# Access Compliance Report Public Rights-of-Way (Curb Ramps)

Intersection ID: 25627      Main Street: KATHRYN BLAIR LN      Cross Street: STALLWORTH DR      Location: NE

ADA ID: 565D6C13A7BA      Ramp Type: PerpDiag      Initial Pass/Fail: Fail      Overall Compliance: No      Severity Score: 8.75

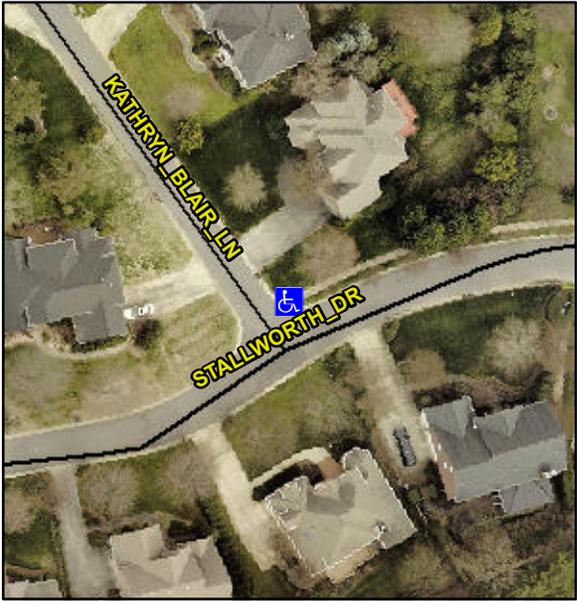
Compliance	Description	Data	Compliance	Description	Data
N/A	Ramp Length (in)	66.0	Yes	Ramp Slope (%)	5.3
No	Ramp Width (in)	47.0	Yes	Ramp XSlope (%)	1.3
N/A	Flare Type LT	N/A	N/A	Flare Type RT	N/A
N/A	Flare Slope LT (%)	N/A	N/A	Flare Slope RT (%)	N/A
N/A	Flare Traversable LT?	N/A	N/A	Flare Traversable RT?	N/A
N/A	Landing Length (in)	N/A	N/A	DWS Provided?	N/A
N/A	Landing Width (in)	N/A	N/A	DWS Contrast?	N/A
N/A	Landing Slope (%)	N/A	N/A	DWS Length (in)	N/A
N/A	Landing X Slope (%)	N/A	N/A	DWS Full Width?	N/A
N/A	Landing Curb? (Y/N)	N/A	N/A	DWS Offset (in)	N/A
N/A	Shared Landing?	N/A			
N/A	Gutter Ponding?	N/A	N/A	Gutter Slope (%)	N/A
N/A	Gutter Lip Ht (in)	N/A	N/A	Gutter X Slope (%)	N/A
N/A	Painted X Walk1?	No	N/A	Painted X Walk2?	No
	X Walk 1 Direction	To W		X Walk 2 Direction	To S
N/A	X Walk 1 Width (in)	N/A	N/A	X Walk 2 Width (in)	N/A
	X Walk 1 Slope (%)	7.8		X Walk 2 Slope (%)	3.5
	X Walk 1 X Slope (%)	2.3		X Walk 2 X Slope (%)	6.0

N/A	Ramp inside XWalk1?	N/A	N/A	Ramp inside XWalk2?	N/A
	Road Slope (%)	1.0	N/A	Clear Space?	N/A
	Road X Slope (%)	7.2	N/A	Clear Space to XWalk (in)	N/A
N/A	Any Obstructions?	N/A	N/A	Storm Grate/Utility Hazard?	N/A
	Obstruction Type			Storm Grate/Utility Type	
		N/A			N/A
			Yes	Surface Condition? (G/P)	Good

Possible Solutions:  
**Remove & Replace Curb Ramp With Two New Directional Ramps or Equivalent.**
